**TOWN OF MOUNTAIN VILLAGE
REGULAR DESIGN REVIEW BOARD MEETING
THURSDAY MAY 2, 2019 10:00 AM
2nd FLOOR CONFERENCE ROOM, MOUNTAIN VILLAGE TOWN HALL
455 MOUNTAIN VILLAGE BLVD, MOUNTAIN VILLAGE, COLORADO
AGENDA**

TO: Design Review Board
FROM: Sam Starr, Planner
FOR: Meeting of May 2nd, 2019
DATE: April 24, 2019
RE: Consideration of a Design Review: Final Review application for a new single-family dwelling on Lot 165-13, 230 Cortina Drive.

Taten Residence
Lot 13 Cortina
Mtn. Village, CO

PROJECT
 DRAWING
**EXTERIOR
 PHOTOMETRIC
 LIGHTING PLAN**

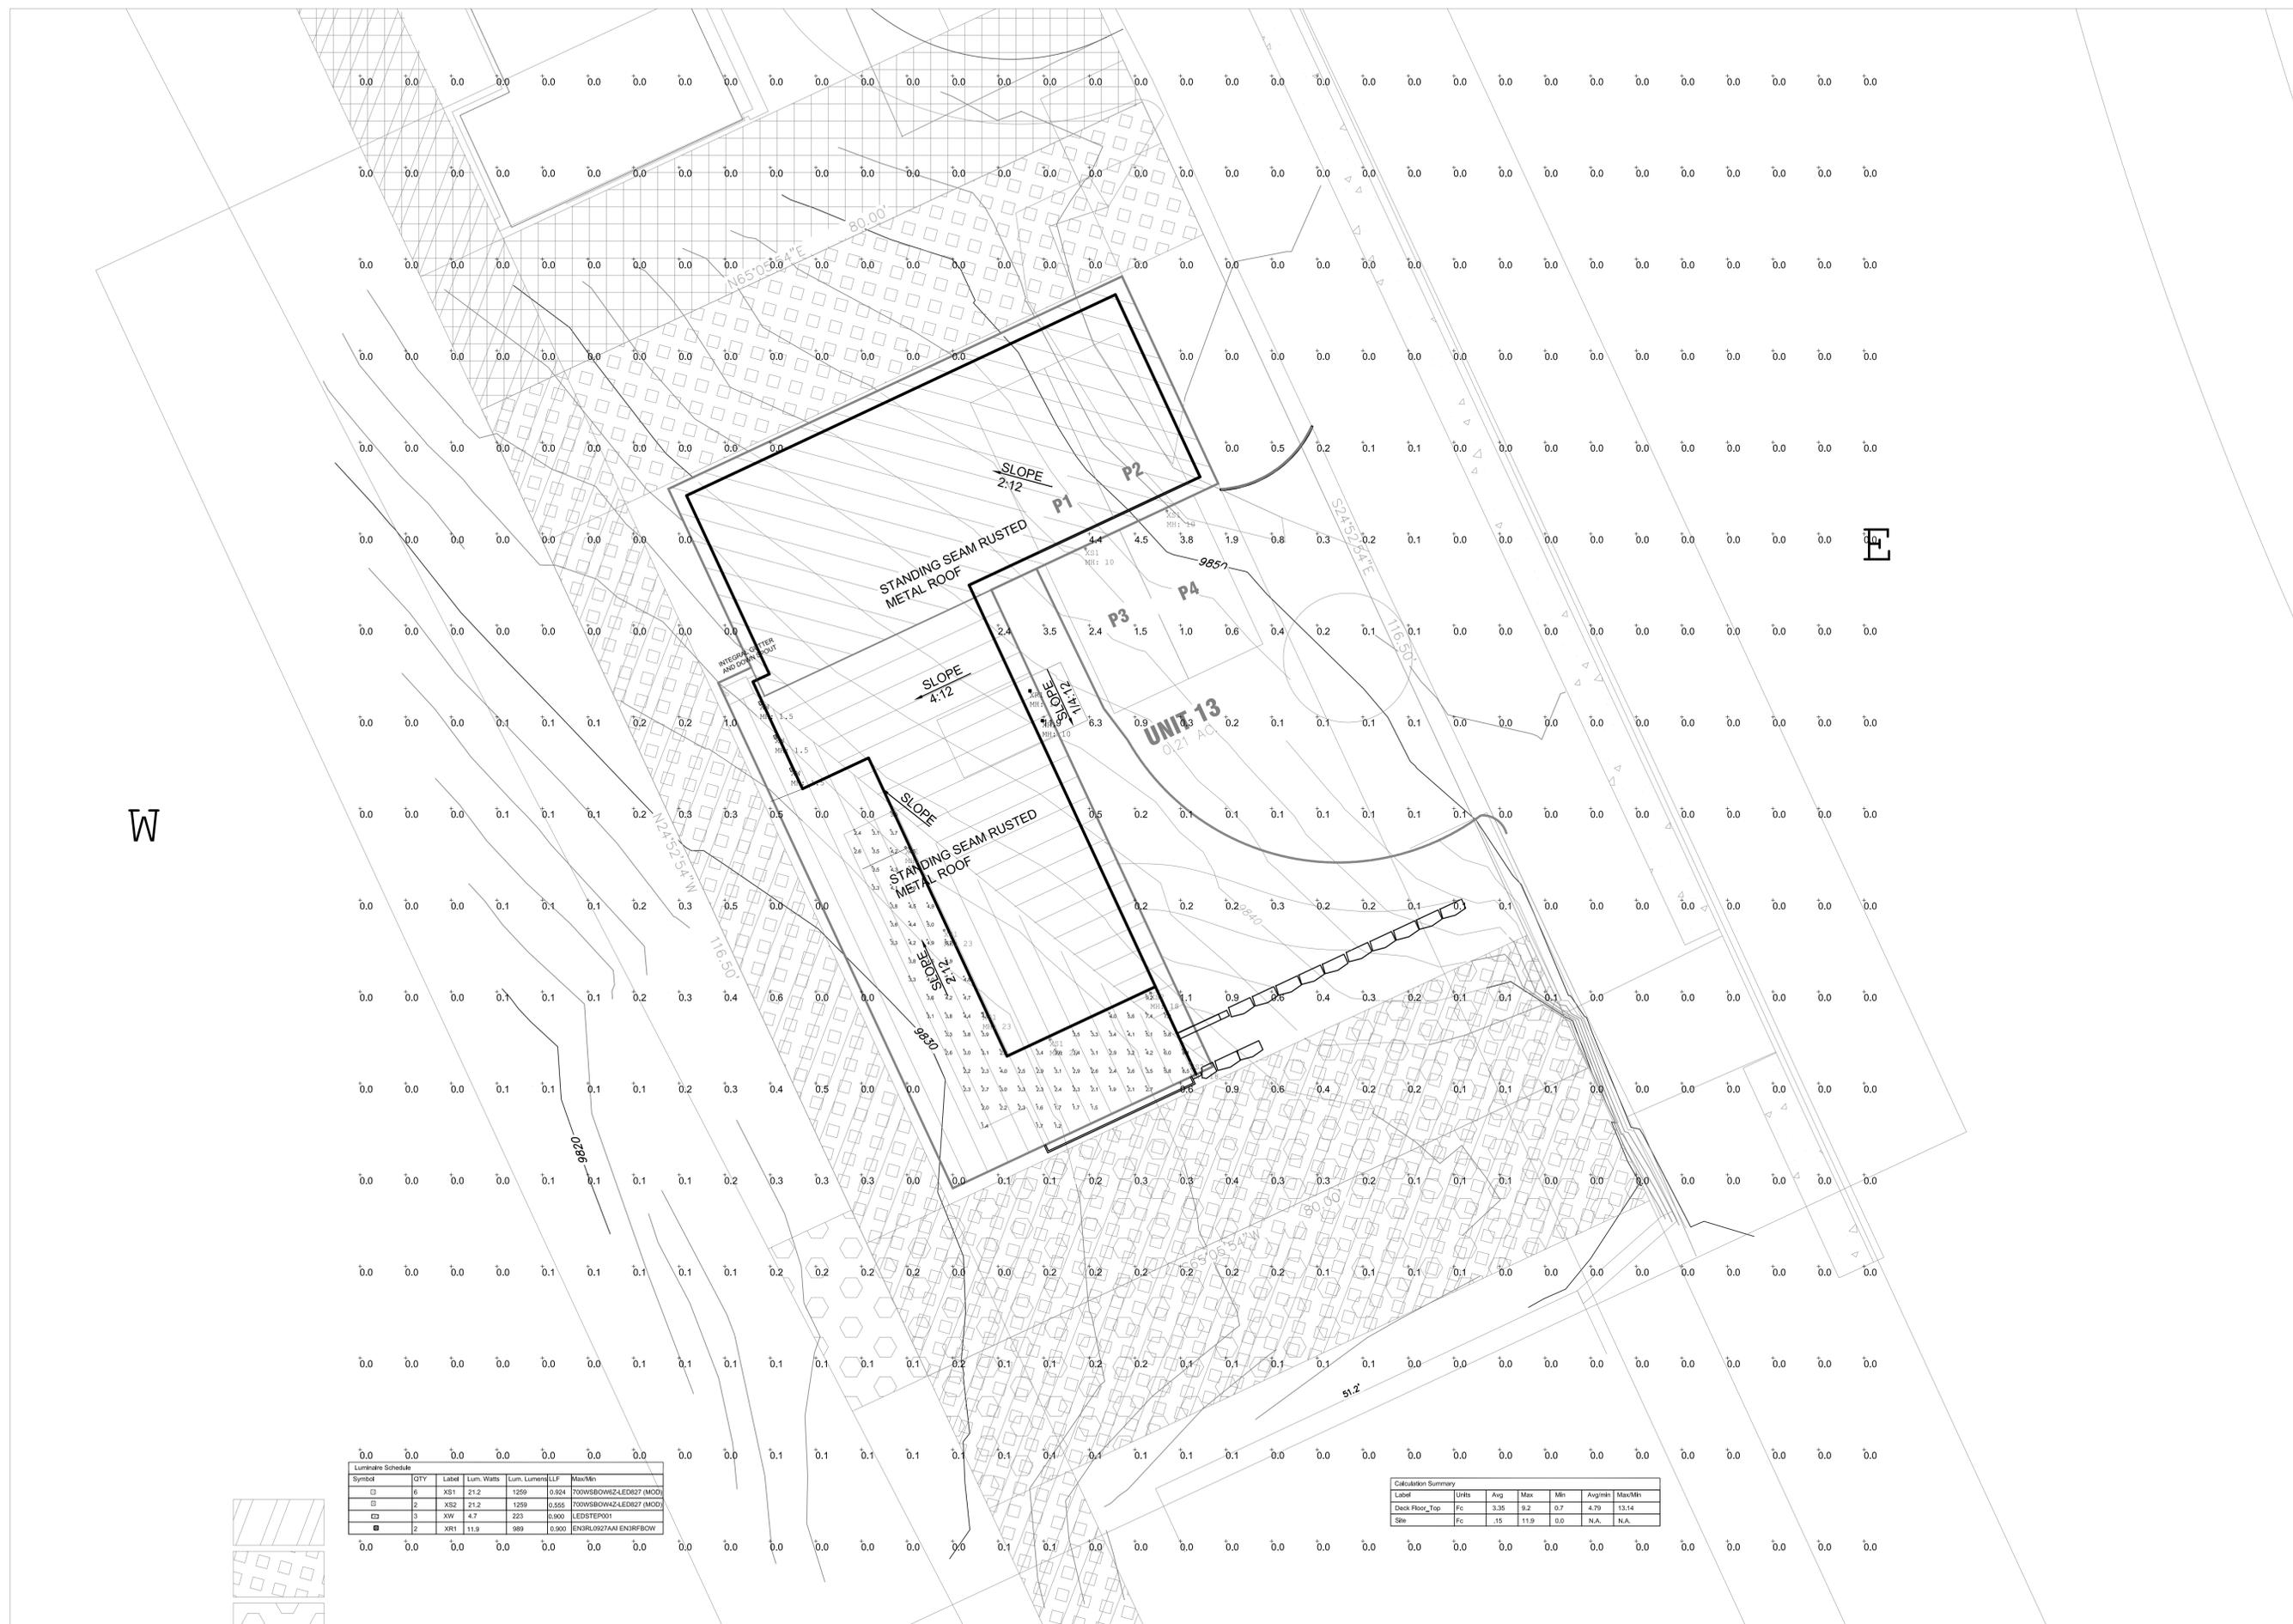
4. *Reconsider lighting plan as proposed to minimize amounts of deck lighting, subject to review of the Design Review Board.*
5. *Drainage needs to be specified in a quantitative sense with input of Colorado Licensed Professional Engineer.*

Applicant has revised the existing lighting plan and photometric lighting study to reflect that the cans previously in the roof overhang have been replaced with downlit sconces. The maximum footcandles found on site is now 11.9, which is down considerably from the Initial Architectural Site Review. However, the Design Review Board will still need to weigh in on the contextual appropriateness of the lighting.

4. *Reconsider lighting plan as proposed to minimize amounts of deck lighting, subject to review of the Design Review Board. SEE A1.1EL*
5. *Drainage needs to be specified in a quantitative sense with input of Colorado Licensed Professional Engineer. SEE CIVIL DRAWINGS*

SCHEMATIC SECTION
SCALE : 1/4" = 1'-0"

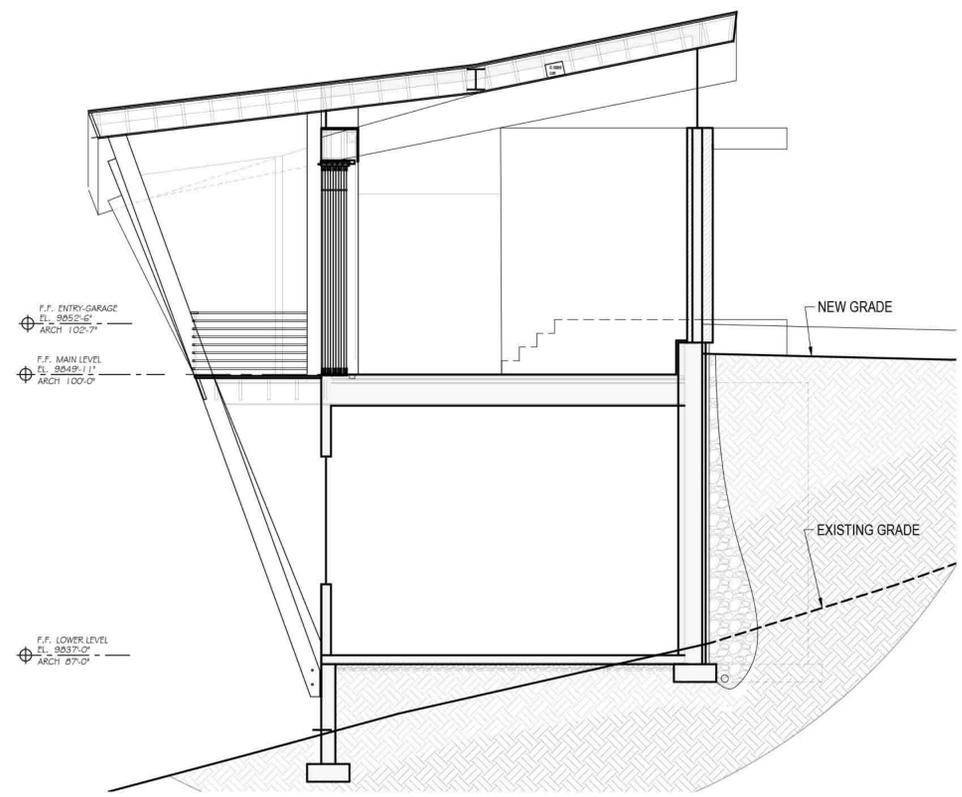
6. *Provide a cross section of construction schematics for the DRB to have confidence that the engineering will not change the appearance of the building as presented to the DRB.*

6. *Provide a cross section of construction schematics for the DRB to have confidence that the engineering will not change the appearance of the building as presented to the DRB. SEE A3.2*
